Facility: Valleyview Park

Address: 2210 Garden Drive Date of Survey: 05/04/10

Photo 3

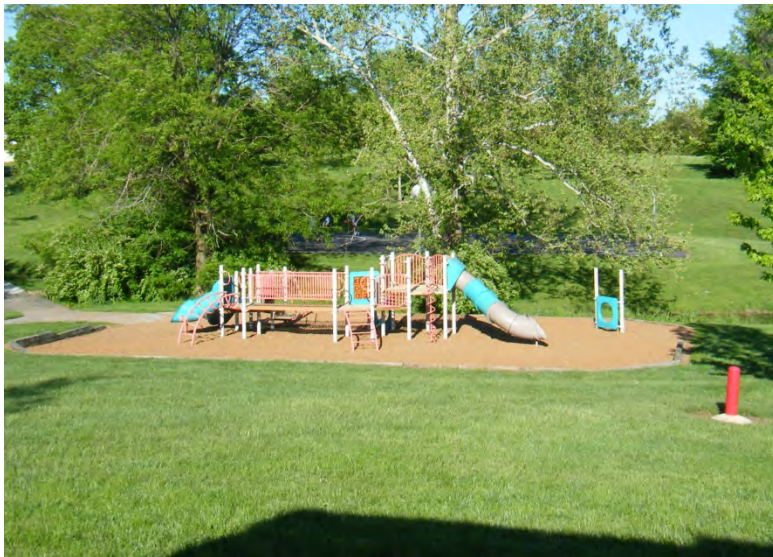
- Refer to site plan included with this report: (H) Replace the existing pea gravel play surfacing with well-compacted wood fiber material in the playground area (~2,016 s.f. area). **Estimated Cost: \$7,056.00**

- Refer to site plan included with this report: (I) Due to remote location of swing-set play area and grade/slope/swale issues to make access difficult and costly, recommend that a new swing-set with at least one child/infant swing and one adult swing be installed adjacent to the existing playground just east of the shelter (see photo 3 below for suggested location). Installation includes ~768 s.f. of new well-compacted wood fiber surface for the swing-set and surrounding “use zone”.
Estimated Cost: \$4,235.00.00
